PRM FASHIONS PVT. LTD

SS SFB-5, KARNAPHULI EPZ, NORTH PATENGA, Chittagong
(22.276409N, 91.796774E)

06th April ,2017

ACCORD
on Fire and Building Safety in Bangladesh

Discrepancies between provided drawing and as-built condition.

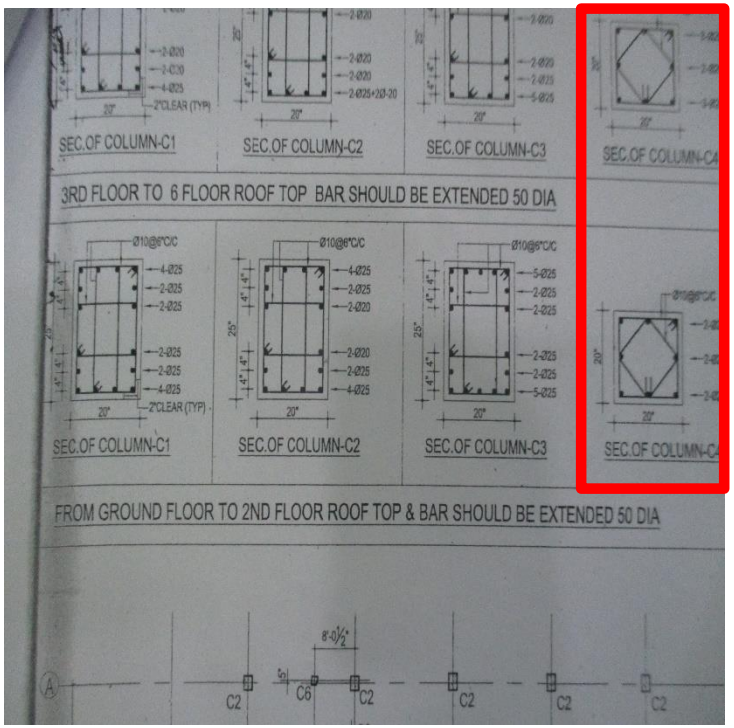
C4 type column shown in as built structural drawing but not found on site. Moreover 8 Nos. of plastic water tanks found at roof which were not shown in architectural drawing.

Item No.	Observation	Recommended Action Plan	Recommended Timeline
1	Discrepancies between provided drawing and as-built condition.	Building Engineer required to prepare As –Built drawings reflecting the actual condition.	**6-weeks**
2	Absence of Load Plan	Produce and actively manage a load plan for all floor plates within the factory giving consideration to floor capacity and column capacity	**6-weeks**
3	Absence of Load Plan	Continue to implement load plan	**6-months**
